AGENDA
COMMISSION ON STORM WATER ISSUES
HEMAN PARK COMMUNITY CENTER
975 PENNSYLVANIA
Tuesday, August 5, 2025
3:30 PM

Draft MINUTES OF THE STORMWATER COMMISSION July 1, 2025

Comments on the June 25, 2025 draft of the Stormwater Master Plan, HR Green Project No. 19180

TO: Storm Water Commission
FROM: John Wagner, Ph.D., Director of Planning and Zoning
DATE: August 5, 2025
SUBJECT: Residential Development – Enclaves at Canton

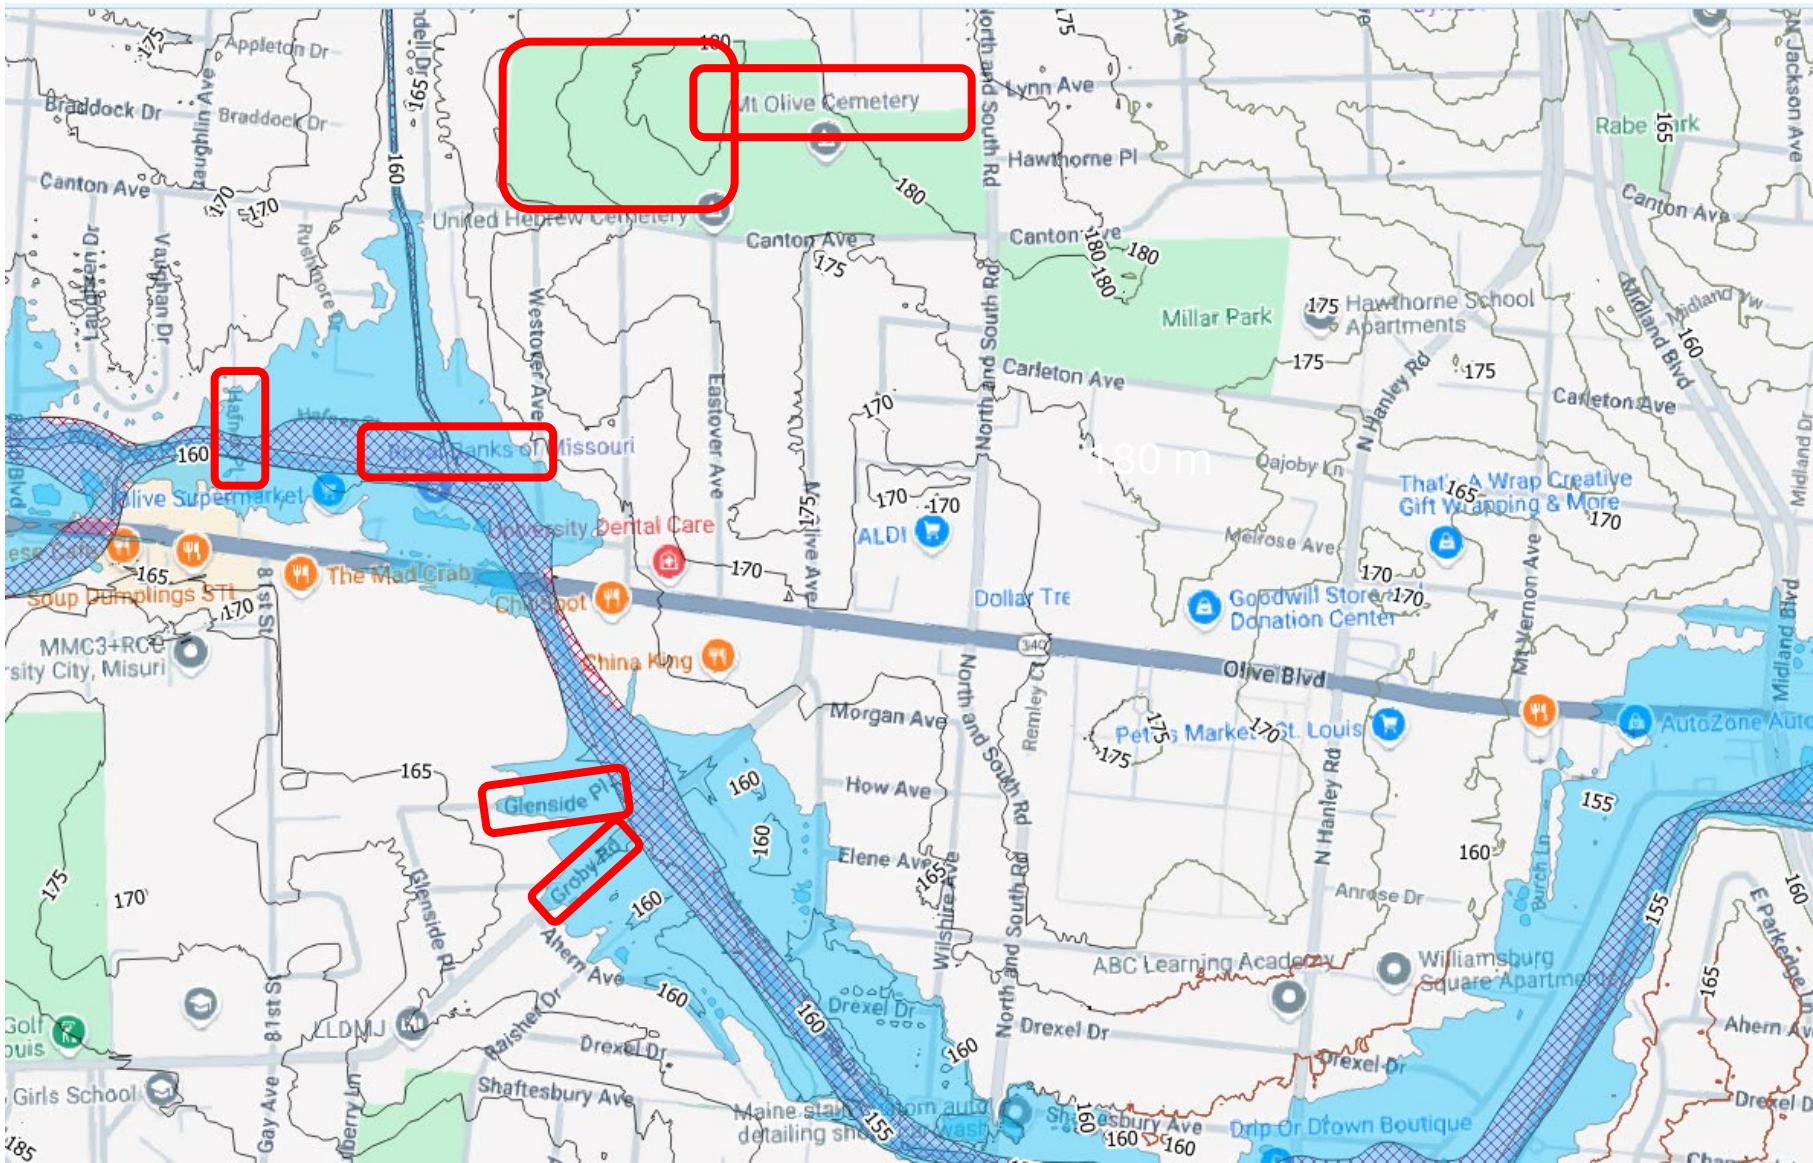
I too, took a look at this and put together a couple of charts that are more qualitative than quantitative. One of the charts has a depiction of the isocontours of the topography superposed with the July 2022 inundation boundary (similar to 2008 at this end of town) and highlighting some of flooding "greatest hits": Hafner, Glenside Place (former councilperson Cusack's area) and Groby. All areas that have had chronic issues. After the 2022 event, I drove down all these streets and witnessed the scores of households with submerged furniture, bedding and appliances that had been affected by the flooding.

I also snapped a picture of the relief map which sits in council chambers. Its casting of shadows offers a more intuitive sense of the topology of the area in question. I note that another place in UCity that has a similar elevation is Ruth Park Golf Course with similar runoff problems along Old Bonhomme. To me, the city should purchase this parcel and turn it into hiking trails with ground cover plantings to further mitigate runoff on the existing streets.

7701 Canton Ave: Rezoning and Development Plan for 11 ac parcel

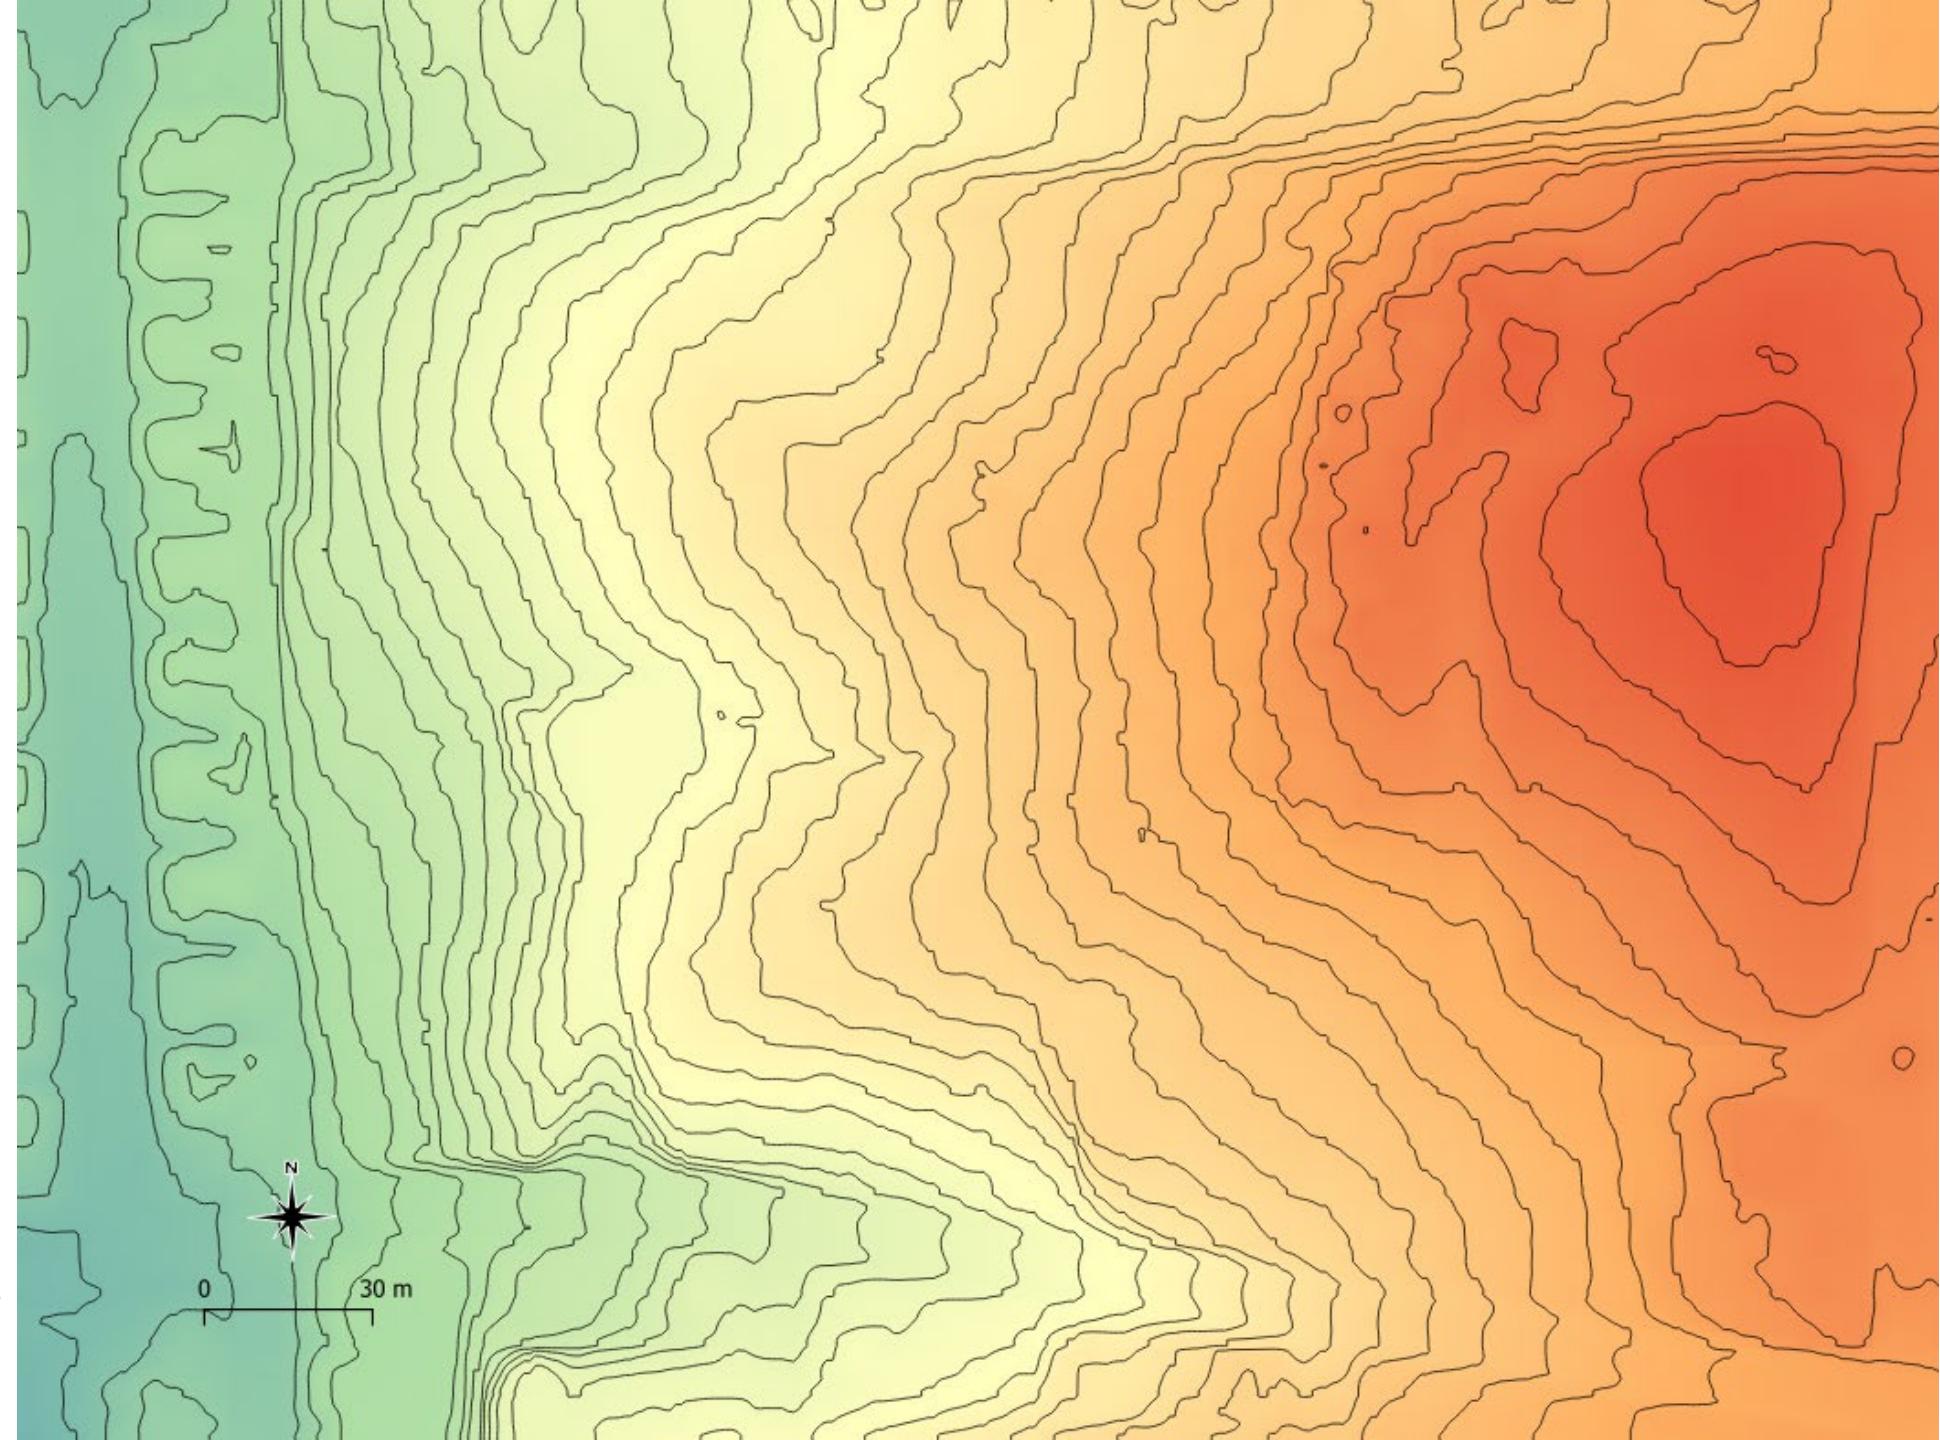
This is a thoughtful plan with some clever elements. Rezoning will convert tax exempt property to taxable property, generating significant revenue for StLCo and UCity.

The apparent sizes of the planned detention basins are 0.34 acres and 0.25 acres. This total is typical for a ~10 ac development in our area. Given UCity's growing problems, this is insufficient. Given the steep topography, tree removal will increase runoff on the homes along Mendel Ave. Do problems already exist? Developer needs to provide current vs planned impervious cover, the number and sizes of trees to be removed, and a revegetation plan.

According to USGS regressions (Southard, 2010), peak flows for forested areas are about 2.5x greater than for developed areas. The impervious cover for the uRdP basin is already in the top 1% of Missouri watersheds.

Removing mature trees is going backwards for UCity, especially when thousands of large trees in St Louis were just destroyed by the May 16 tornado. Runoff to the RdP will be increased, while heat island effects alone will magnify storm intensity. This increased runoff will enter the N tributary immediately west of Mendel Ave, then will flow only 0.25 mile due south to its confluence with the main uRdP thalweg between the Hafner and Westover Apts., further impacting one of UCity's most flood-prone neighborhoods (see MSD facilities map 16K). A remnant refugia will be destroyed. Why rezone to allow this? Public comments are essential.
